**LEE COUNTY BOARD OF ADJUSTMENTS AND APPEALS
Community Development/Public Works Center
1500 Monroe Street, 3RD FLOOR CONFERENCE ROOM 3C**

Case #ADM2015-00004, Coconut Cove

The applicant is requesting a variance of LDC Section 10-384(c)(1)

RE: Case #ADM2015-00004 (DOS2015-00070) – Coconut Cove

FLORIDA CERTIFICATE OF AUTHORIZATION #0001
COCONUT COVE
BOCA WATER LOOP
VARIANCE EXHIBIT

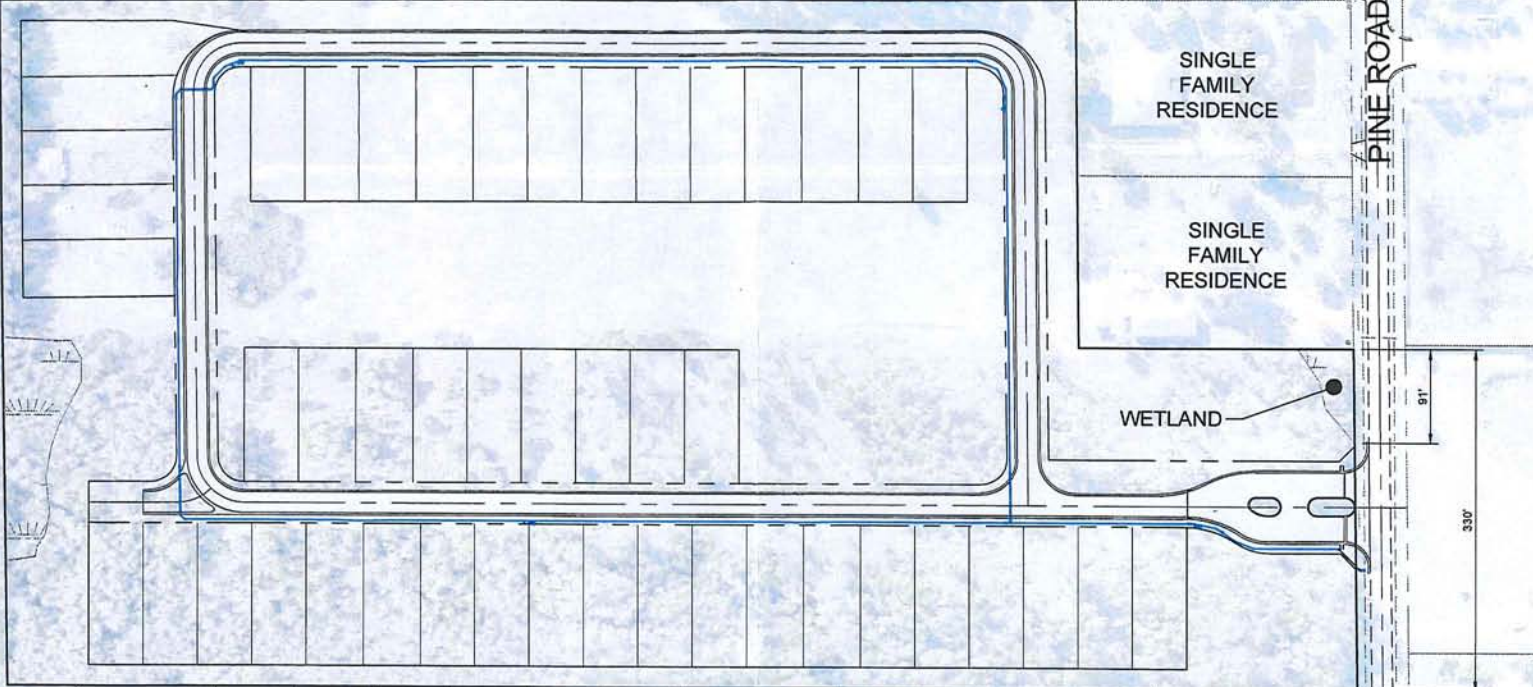
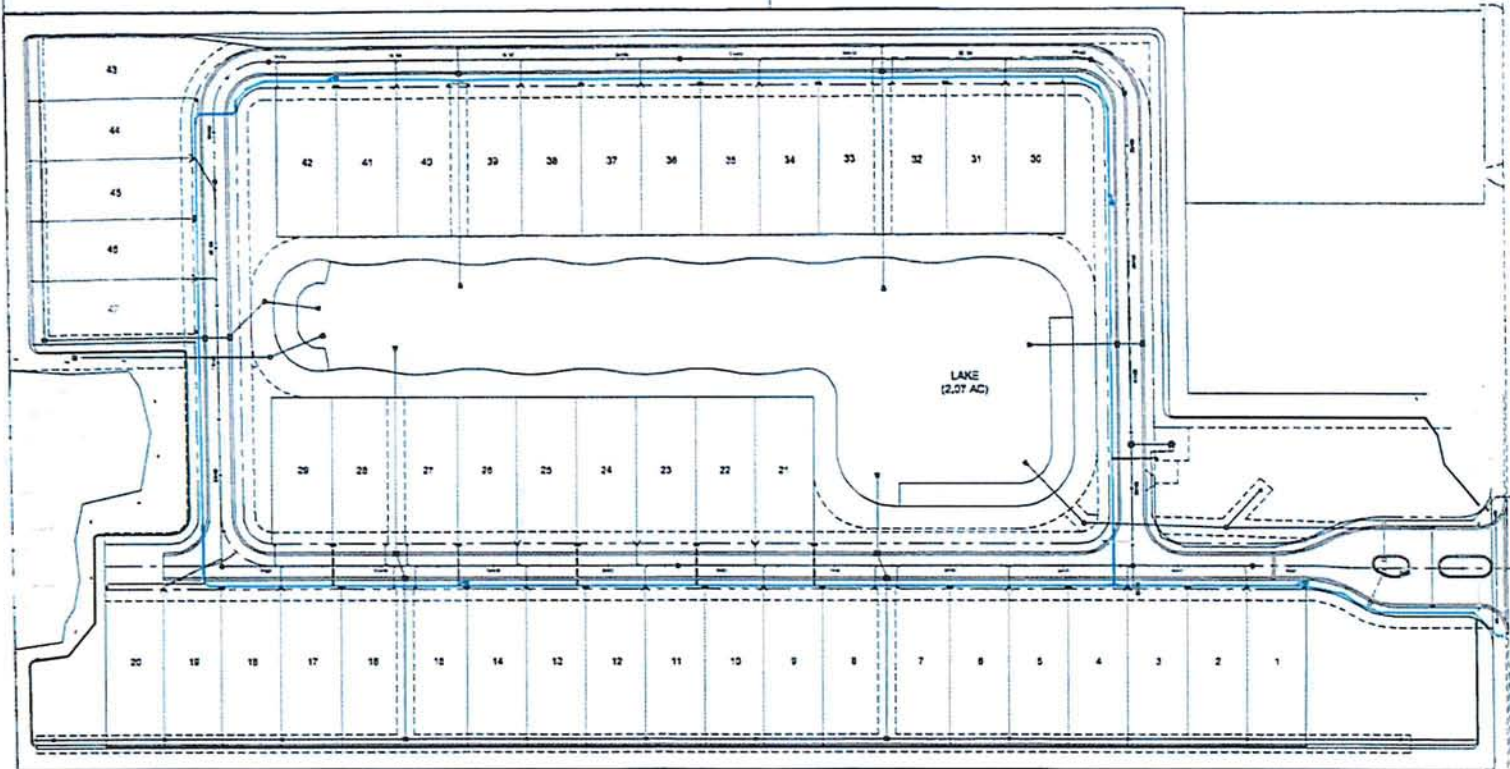
As per our conversation on the pre-development and review of the proposed site plan for Pineland Preserve, you have requested a deviation from the LDC, regarding the external water main loop. We note the infill nature of the subject property precludes external looping and understand that you will be looping internally to the project which will provide adequate fire flow at each hydrant location. During the review of the proposed site, the fire district agrees, there is no reason to object this main water loop for the development. Please find this no objection letter in regards to the proposed development plan revision on Pine Road. After reviewing Deviation Exhibit C - Water Deviation; maintaining flow rates will be consistent with rates established in Exhibit C upon installation and at time of certification and/or sign off, and due to these items being accomplished, we find no objection to the proposed project. Please feel free to contact me at (239) 267.7525 if you require additional information. Trusting this meets with your approval, I remain,

Based on the forgoing, staff recommendation is to approve the variance request with the condition that internal water mains are 8 inches in size and all other LDC requirements are complied with.

COCONUT COVE
 WATER MODEL EXHIBIT

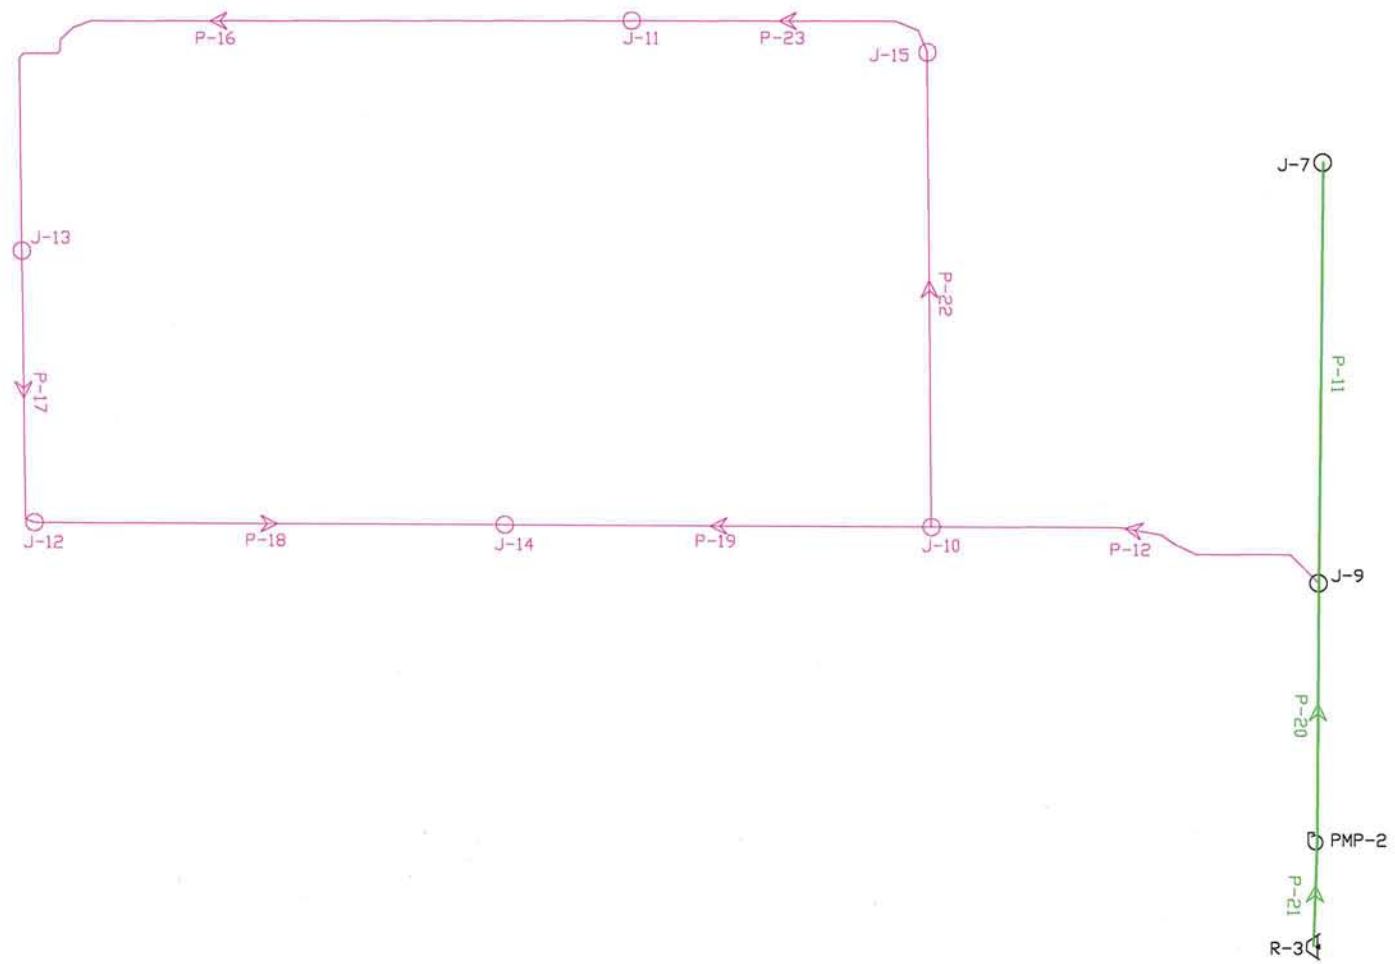
Unfortunately, the water model included in this Deviation Request Package attached to Pam Hendry's e-mail still shows 6" mains looped internally rather than 8". I would be more comfortable with the request moving forward if the Deviation Request Package included the model with 8" mains looped internally.

Lee County Utilities has provided an email supporting the request, on the condition that the internal loop consists of 8 inch water mains.
